November 13, 2015

RE: Comments on Tentative Schedule Order for NRG California South LP
Mandalay Generating Station, Oxnard, CA (NPDES No. CA0001180, CI NO. 2093

Attachments: Aerial photo of MGS beach discharge

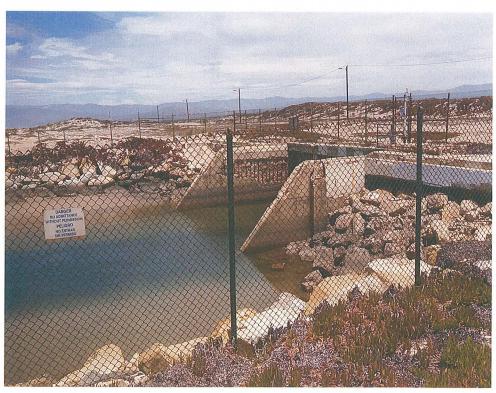
Finally, the beach over which the discharge water travels is a public beach. The discharge, moving at a visible current when the MGS is fully operating, presents an attractive nuisance and safety hazard to the public and inhibits horizontal coastal access in possible violation of the Coastal Act. Photographs are included that show the discharge ponding, condition of the structure, and people and pets wading in the discharge. The proposed P3 facility application indicates NRG will continue to use the beach outfall discharge even though the greatly reduced amount of discharge (NRG's CEC application states total sanitary and wastewater discharge at 19 AFY) could be redirected either to the adjoining Edison Canal or into the City's sanitary sewer system, assuming appropriate water quality requirements and permits are obtained. Discharge into the Edison Canal may actually benefit the canal's water quality by introducing in-flow at what could otherwise be a stagnant 'dead end' that is 1.7 miles from the Channel Islands harbor.

The City requests that the LARWQCB add a condition on the TSO that Discharge Point 001 be discontinued and demolished when the MGS ceases operation and is decommissioned after December 31, 2020 when the MGS must comply with the Once-Through-Cooling policy. NRG has already indicated in the AFC application that the MGS will be decommissioned.
